NRC Staff Responses to Public Comments on
Draft Regulatory Guide DG-1146
“A Performance-Based Approach to Define the Site-Specific
Earthquake Ground Motion”

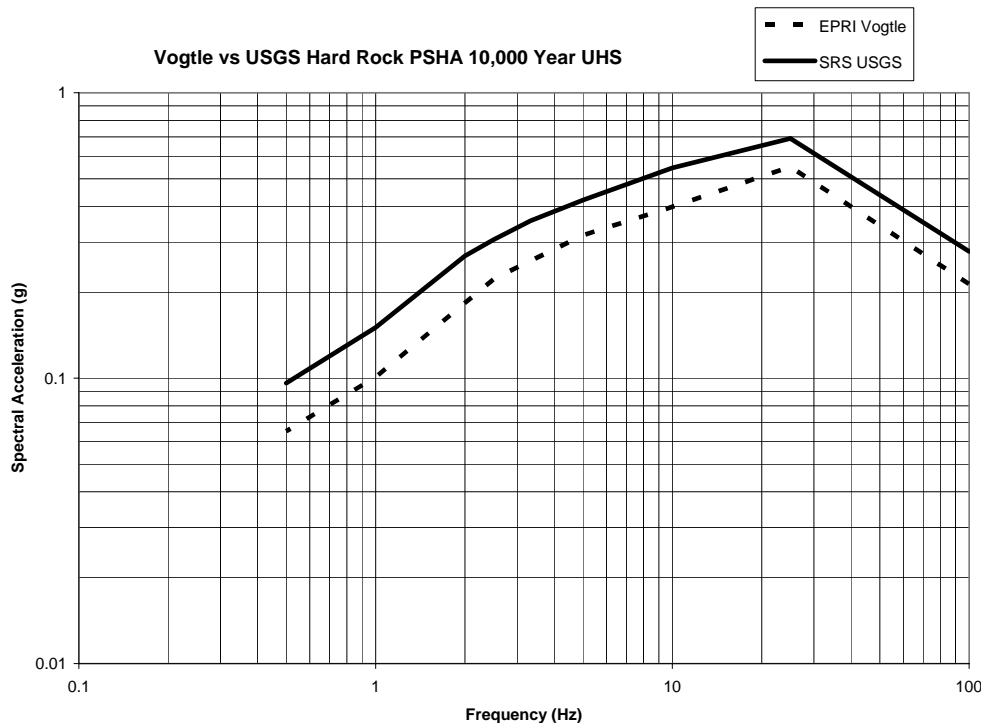
To compound these issues, the recent submission of the Vogtle ESP application, Site Safety Analysis Report, further demonstrates that PSHA stability does not exist. Consistent with other ESP applications (North Anna, Grand Gulf, Clinton), the Vogtle applicant has chosen to use an update to the EPRI PSHA to assess seismic hazard and establish appropriate ground motion for seismic design. The update to the EPRI PSHA for Vogtle, however, is significantly different than the EPRI PSHA work used by the preceding three ESP applicants, and inconsistent with material provided by EPRI as part of the ongoing dialog regarding resolution of seismic hazard issues (Program on Technology Innovation: Assessment of a Performance-Based Approach for Determining Seismic Ground Motions for New Plant Sites, V1 Performance-Based Seismic Design Spectra, V2 Seismic Hazard Result at 28 Sites; EPRI Technical Reports (1012044 and 1012045). Specific issues related to the EPRI PSHA update used for Vogtle are provided following the remaining comments.
